URGENT FIELD SAFETY NOTICE

**Endoflip v1.0 System, Endoflip System v1.0 Refurbished, and DL
Endoflip v1.0, all serial numbers**

Medtronic Reference: FA1538

Initialization Screen

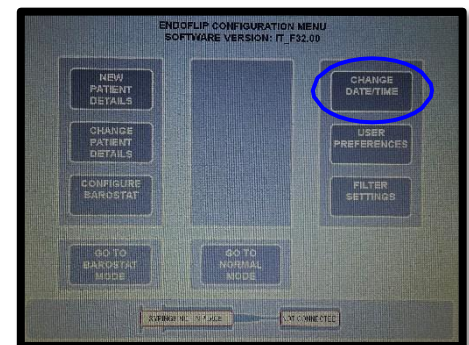
1. Turn Endoflip™ system on; wait for approximately 30 seconds for initialization screen to appear.
2. On the **initialization screen**, select and press the **MENU** button to navigate to Endoflip **Configuration Menu screen**.

Configuration Menu Screen

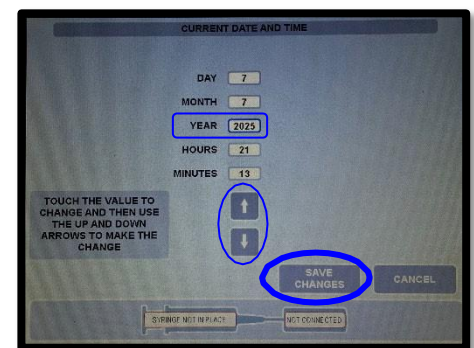
3. On the Endoflip **Configuration Menu screen**, select and press the **CHANGE DATE/TIME** button to navigate to the **Current Date and Time screen**.
